Access Compliance Report

Public Rights-of-Way

(Curb Ramps)

Intersection ID: 11164	Main Street: CAMP_GREENE_ST	Cross Street: FREEDOM_DR	Location: E
ADA ID: 1DFBE8BFE37B	Ramp Type: Perp	Initial Pass/Fail: Fail	Overall Compliance: No
Severity Score: 13.75			
Codes/Mitigation Info/Possible Solution		Field Measurements/Component Compliance

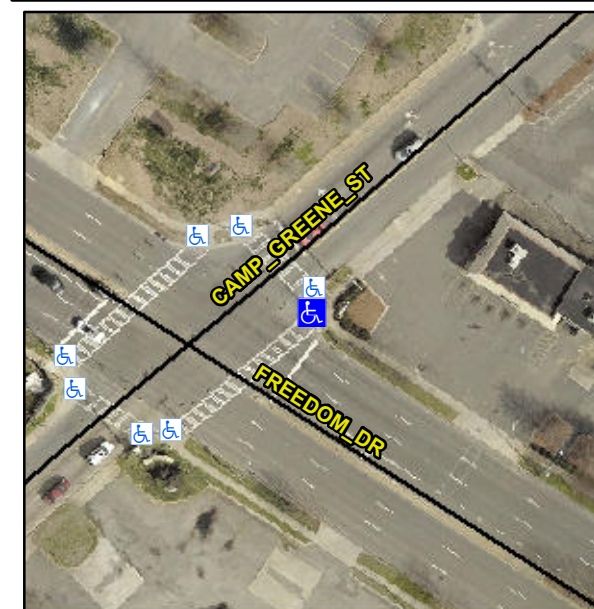
Not Found, R304.2.2

Compliance	Description	Data	Compliance	Description	Data
N/A	Ramp Length (in)	76.0	No	Ramp Slope (%)	8.8
Yes	Ramp Width (in)	48.0	Yes	Ramp XSlope (%)	4.8
N/A	Flare Type LT	N/A	N/A	Flare Type RT	N/A
N/A	Flare Slope LT (%)	N/A	N/A	Flare Slope RT (%)	N/A
N/A	Flare Traversable LT?	N/A	N/A	Flare Traversable RT?	N/A
N/A	Landing Length (in)	N/A	N/A	DWS Provided?	N/A
N/A	Landing Width (in)	N/A	N/A	DWS Contrast?	N/A
N/A	Landing Slope (%)	N/A	N/A	DWS Length (in)	N/A
N/A	Landing X Slope (%)	N/A	N/A	DWS Full Width?	N/A
N/A	Landing Curb? (Y/N)	N/A	N/A	DWS Offset (in)	N/A
N/A	Shared Landing?	N/A			
N/A	Gutter Ponding?	N/A	N/A	Gutter Slope (%)	N/A
N/A	Gutter Lip Ht (in)	N/A	N/A	Gutter X Slope (%)	N/A
N/A	Painted X Walk1?	Yes	N/A	Painted X Walk2?	N/A
	X Walk 1 Direction	To SW		X Walk 2 Direction	N/A
N/A	X Walk 1 Width (in)	70.0	N/A	X Walk 2 Width (in)	N/A
	X Walk 1 Slope (%)	0.7		X Walk 2 Slope (%)	N/A
	X Walk 1 X Slope (%)	6.8		X Walk 2 X Slope (%)	N/A

Remove & Replace Entire Ramp.
